**MAJOR PROJECT ASSESSMENT:
Residential Development Buildings 7 & 8
61 Mobbs Lane, Epping- Former Channel 7 site
MP10_0158**

Director-General's
Environmental Assessment Report
Section 75I of the
Environmental Planning and Assessment Act 1979

June 2011

Figure 10: Rear Building Setbacks

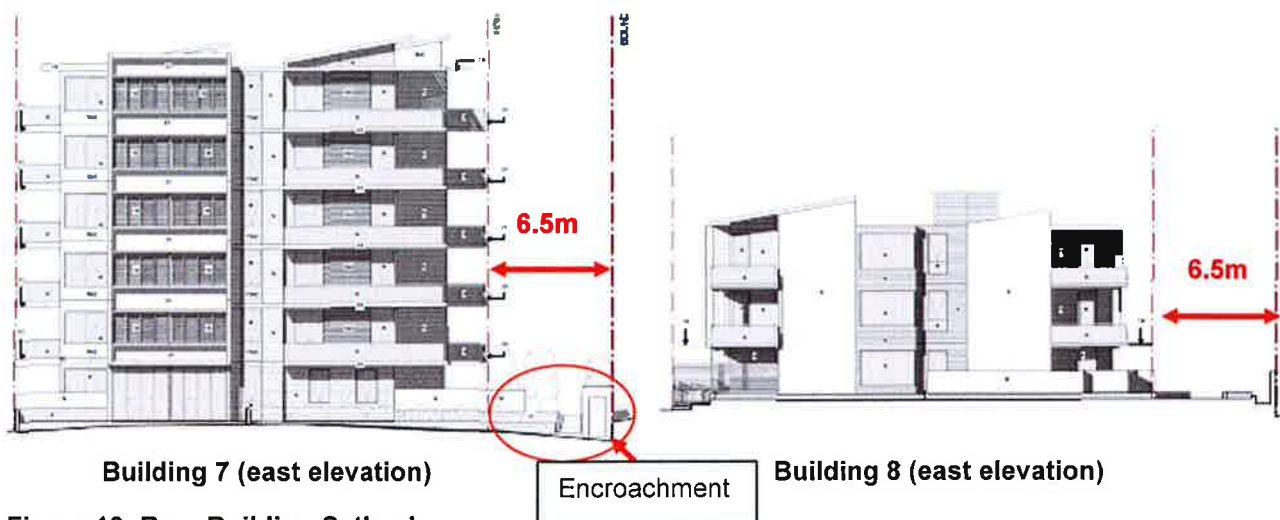
The proposal complies with all aspects of the approved Concept Plan (as modified) except for a partial variation sought to the prescribed rear (northern) setback of Buildings 7 and 8. The Concept Plan (as modified) requires Buildings 7 and 8 to be setback 6.5 metres from the rear boundary, adjacent to the TAFE complex. The main building form of both buildings, including balcony projections, complies with the required setback (**Figure 10**). The application includes ancillary structures, at ground level only, within this setback including 2 fire escape stairs from the basement levels (with varied heights of 1.2m and 2.5m above ground level due to changes in levels) and the ground floor courtyards. The Department considers the variation to be minor as the proposed encroachment is at ground level only and will not affect the existing amenity enjoyed by the TAFE or surrounding residents.

The Department considers that the proposed setback is acceptable given it generally complies with the approved setbacks stipulated within the approved Concept Plan (as modified).

Figure 11: Building Separation Distances

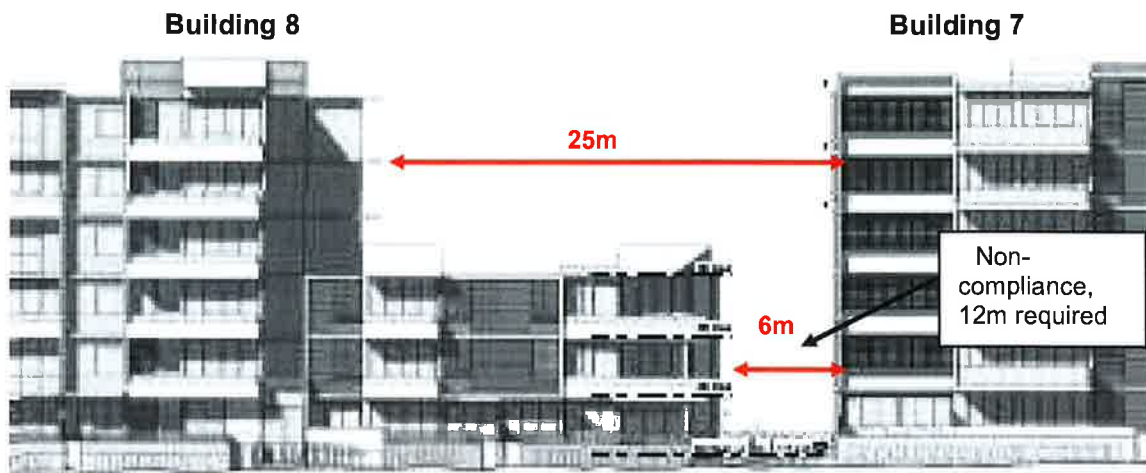
The RFDC recommends minimum building separation distances of 12 metres up to 4 storeys and 18 metres above 4 storeys. Separation distances between Buildings 7 and 8 range between 6-7 metres at ground, first and second floor levels, increasing to a distance of 25 metres at third, fourth and fifth floor levels. Therefore, the proposal does not strictly meet the recommended minimum RFDC separation distances for the first three levels, as illustrated in **Figure 11** below. It should

however be noted that the proposal has been design in accordance with the approved Concept Plan which approved a 6m separation distance between buildings 7 and 8.

The RFDC advises that *'Developments that propose less than the recommended distances apart must demonstrate that daylight access, urban form and visual and acoustic privacy have been satisfactorily achieved.'*

Despite the variation from the RFDC recommended separation distance, at ground, first and second floor levels, the proposal achieves satisfactory amenity for future residents and an appropriate built form.

Figure 12: Facing Windows- Buildings 7 and 8 (windows shown in red, highlight windows in blue)

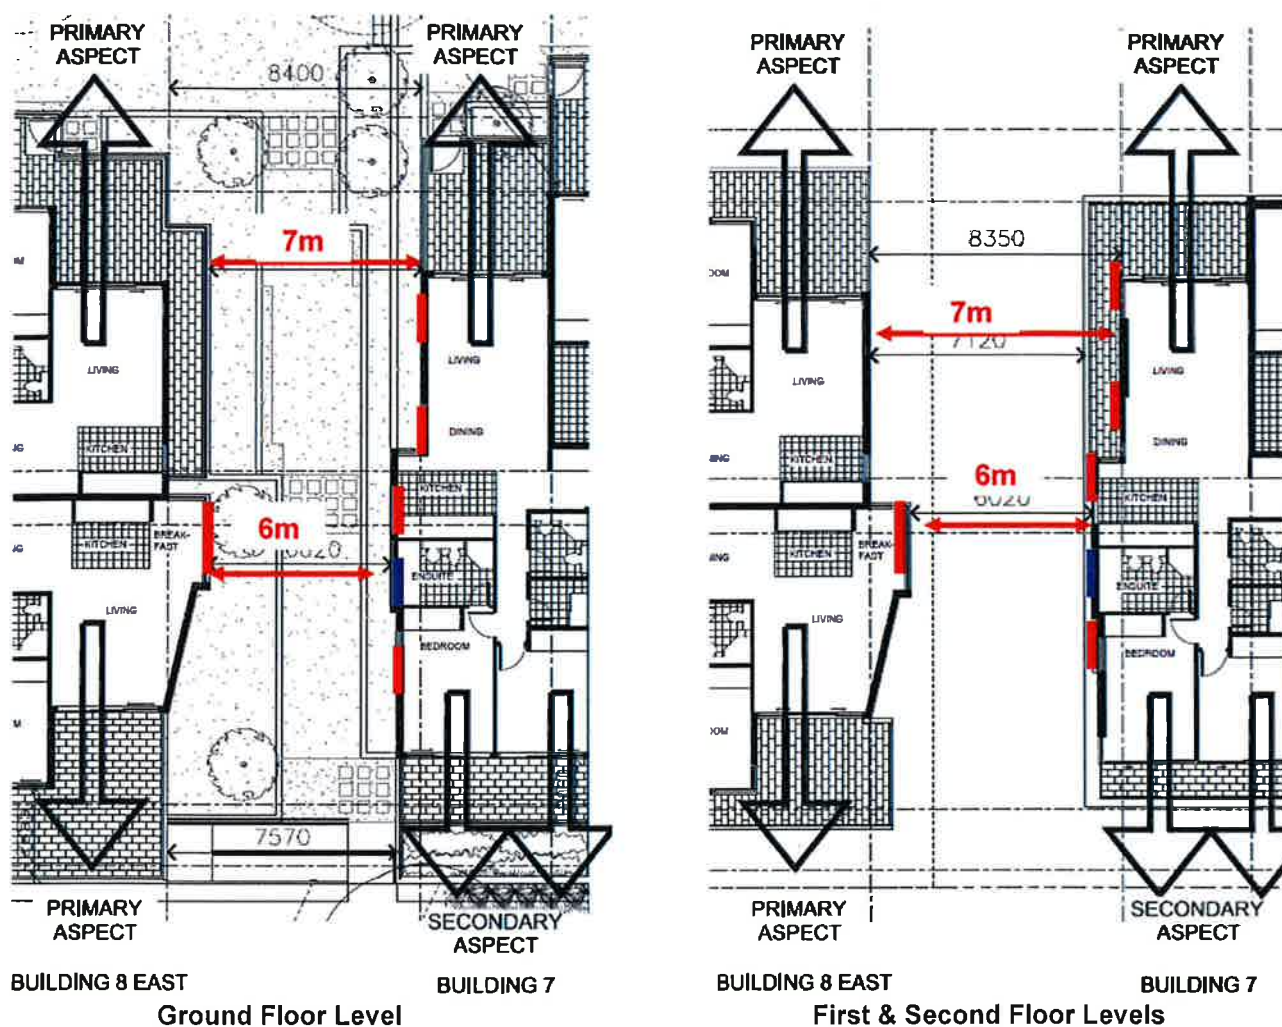
The proposal has addressed visual privacy by orientating units within the two buildings towards the north and south. Windows provided on opposite side elevations are secondary openings. Where openings do occur, they are generally limited in width and have been located to be off-set from windows on the opposite elevation. In addition, bathrooms have been provided with highlight windows (**Figure 12**).

The proposal also includes a number of design elements to assist with visual privacy including operable, external screens or louvers to the west elevation windows of Building 7, providing additional privacy to residents. At the ground floor level, the raised planters and proposed shrubs will provide privacy to the ground floor units.

To provide adequate privacy to the opposite balconies on the first and second floor levels, a condition is recommended requiring privacy screens to the eastern elevation of relevant balconies within Building 8.

Figure 13: Building articulation (Building 8)

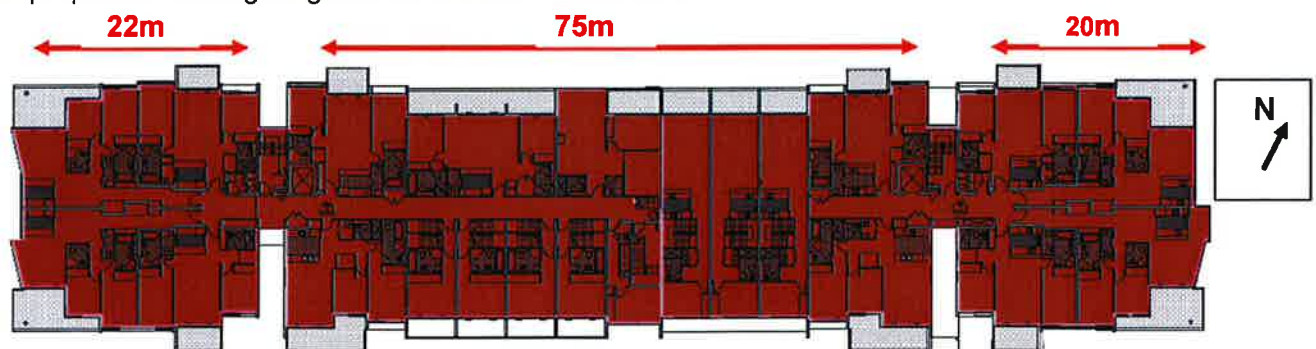
Council also raised concern regarding the length of Building 8 (approximately 103 metres), citing the Parramatta DCP 2005 maximum building length control for multi-unit dwellings (20 metres). The length of Building 8 is consistent with the approved Concept Plan. Building design features including the stepped building heights and building articulation including indented lobby access act to break up and reduce the bulk of the building (**Figure 13**). Additional contributors including a variety of building materials and colours and the use of landscaping (approved and proposed) at street level, will further assist in breaking up the appearance of the building's mass and bulk, while providing visual interest along the street. Given the building's acceptable streetscape appearance, the proposed building length is considered acceptable.
